Request for a Plan Amendment: PID 00137802

SETON RIDGE

WALKWAY ROUTES

Map 9Df: Seton Ridge Neighbourhood Plan

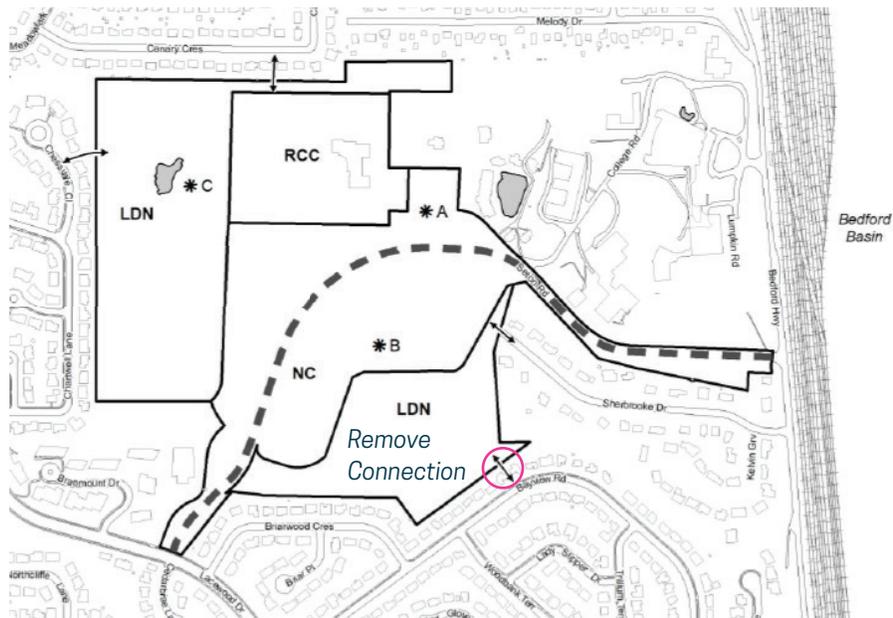
Paul, as discussed at our last Seton meeting, Southwest would like to file a plan amendment for the Halifax Municipal Planning Strategy to remove the pedestrian trail connection from Seton Ridge to Bayview Road. The request, specifically, is to amend Map 9Df to remove this connection (see below) for the reasons noted below to advance Southwest's Seton Ridge development.

C-SK17

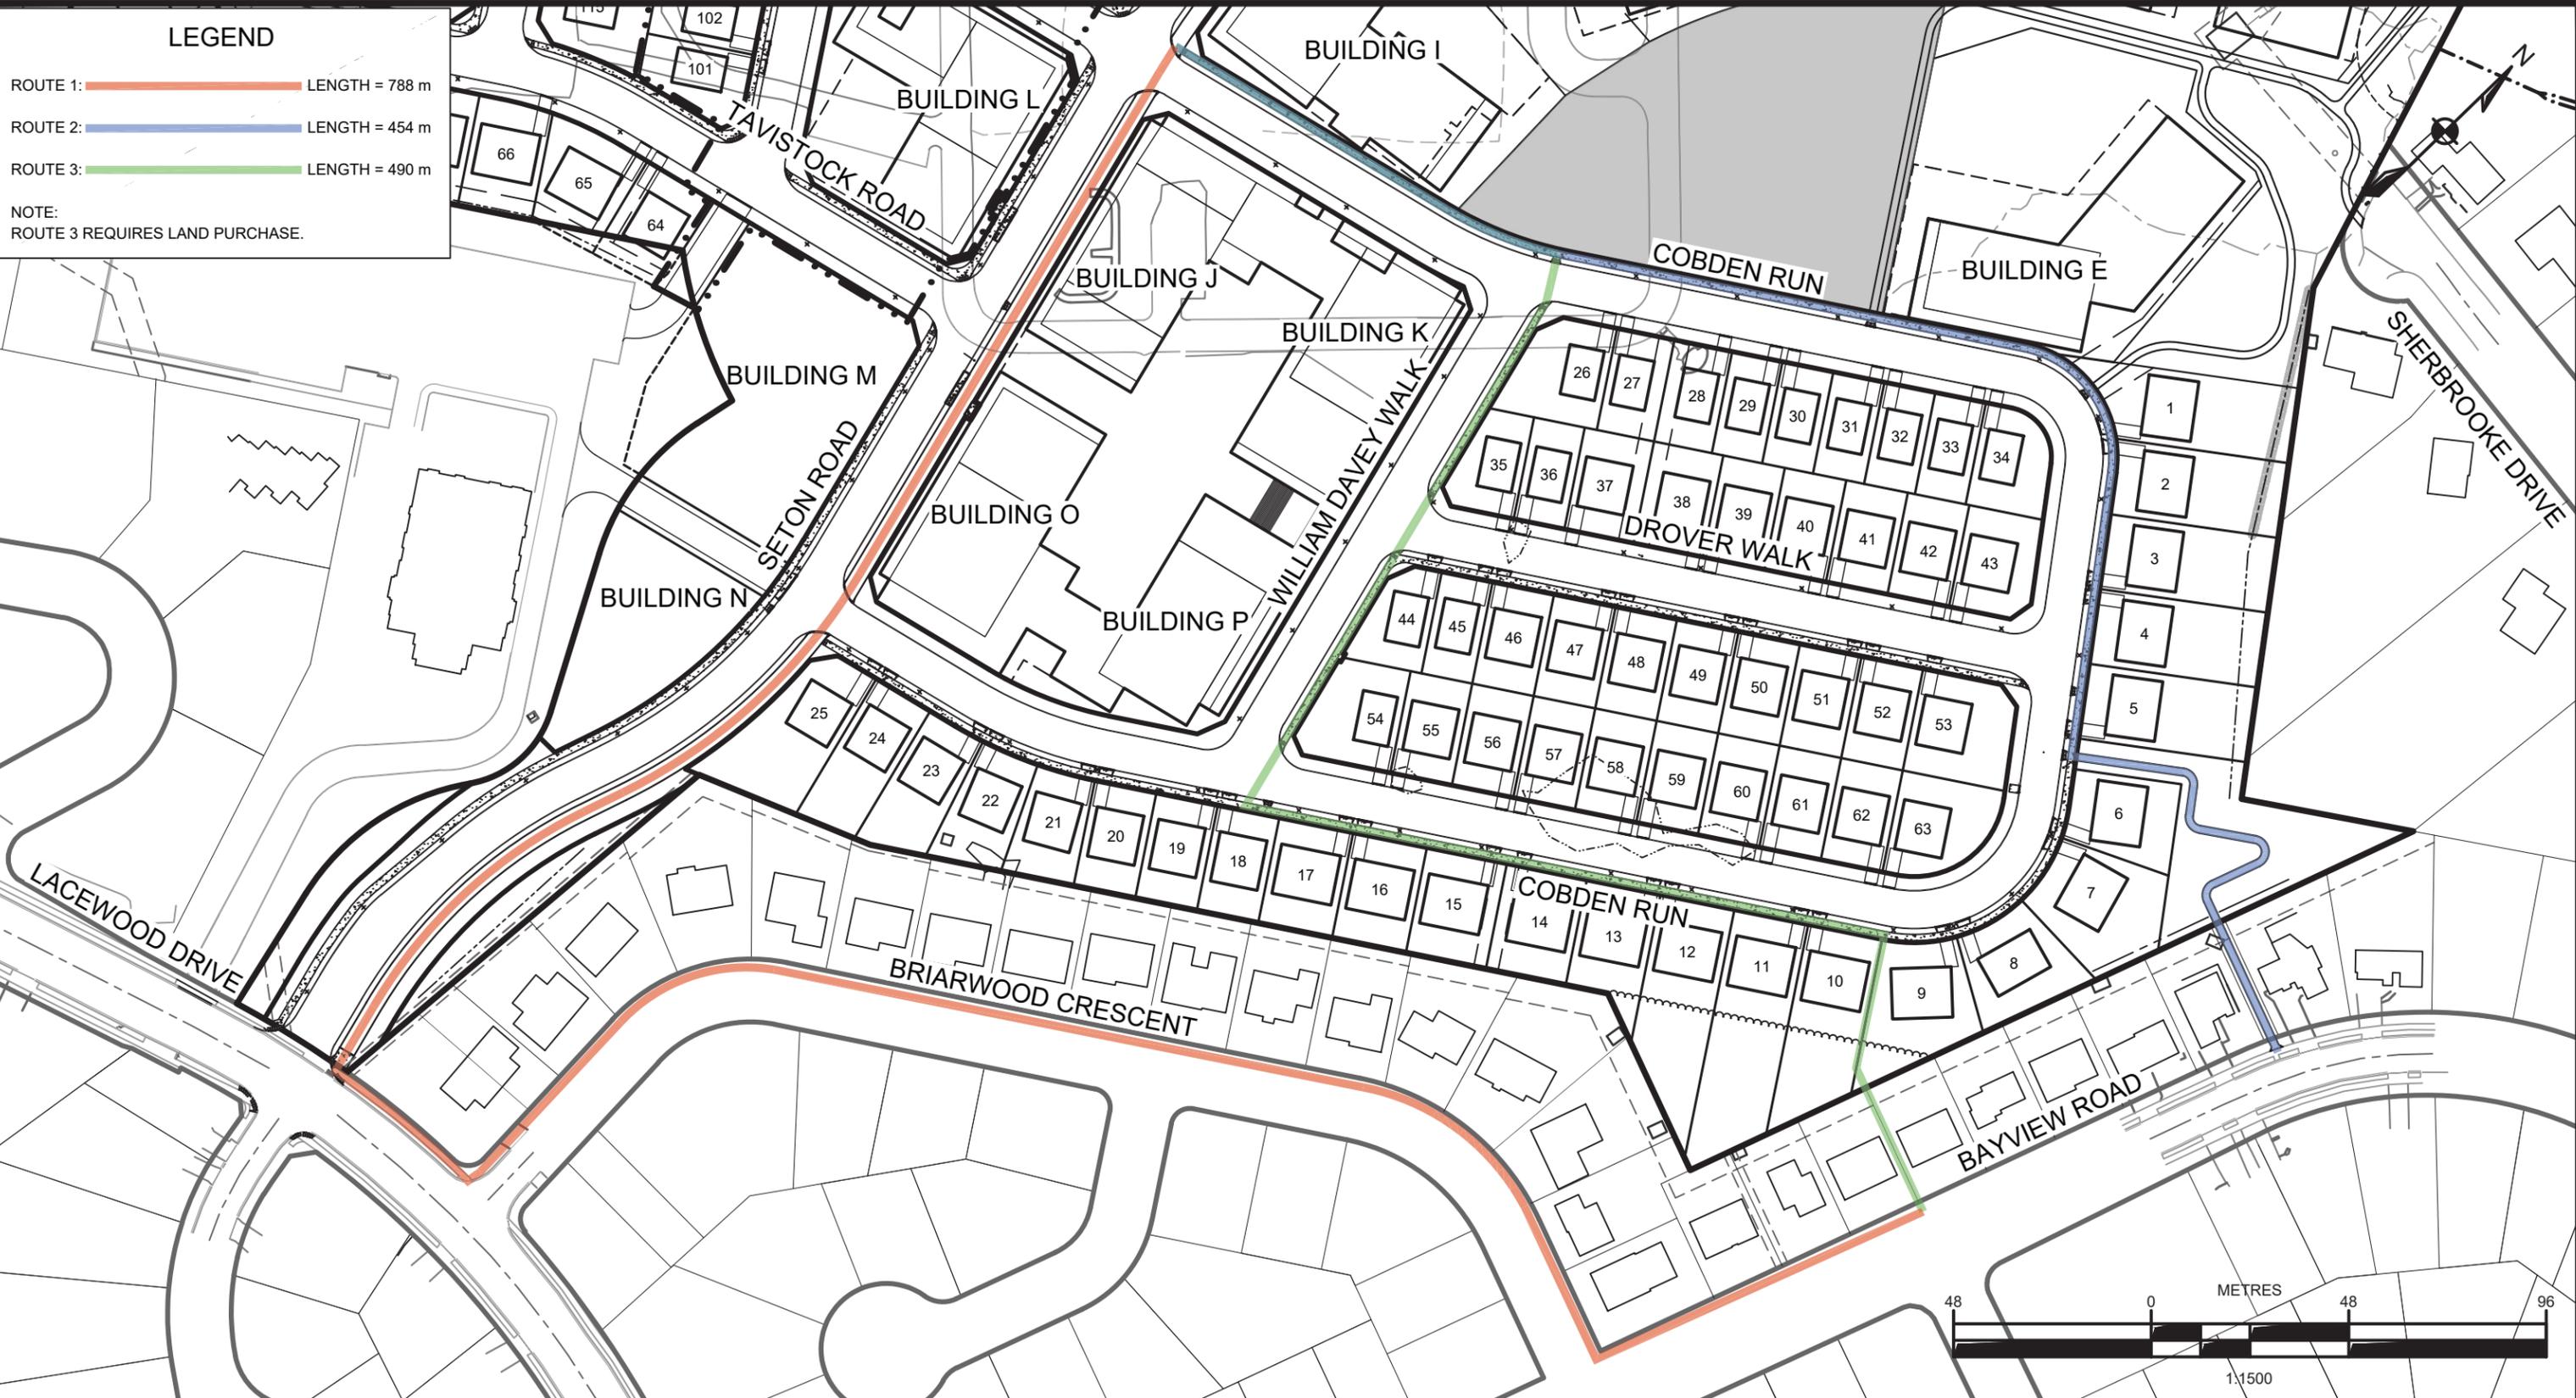
In the case of the Bayview Road trail connection, if HRM will not accept a 3.66m wide easement, there is no reason to provide a 6m wide easement on the Seton Ridge lands if a trail would not be accepted by Parkland Planning. This property also includes some very significant grade changes that would require large retaining walls along the length of the trail further compounding the width of the easement to make room for retaining walls and footings. For this connection, there seems to be no easy way to design this trail in a manner that would be acceptable to HRM. As a result, we would like to amend map 9Df to remove this connection. Section 8A.8 of the MPS states that *"The Seton Ridge Neighbourhood shall prioritize walking, cycling and transit use. The transportation network shall consist of: (c) pedestrian walkways, shown on Map 9Df, that connect the development with surrounding neighbourhoods"*. Southwest has completed a GIS analysis to determine which properties would be impacted by eliminating this trail connection to the new Seton Village Centre. The new Seton Road extension (which has an AT Multiuse Trail) is the shortest connection to the urban core for almost 90% of the surrounding walking residents. Only a small number of houses on Bayview, Trillium Terrace, Woodbank Terrace and Lady Slipper Drive would have a slightly longer walk to the Seton Urban Core if this Bayview trail connection was removed. We believe these impacted areas are still within a very comfortable walking distance to the Urban Core by eliminating this trail connection. In a worst case scenario, the removal of this trail will only add another 334 m to the walk for a small number of properties (see attached map prepared by DesignPoint).
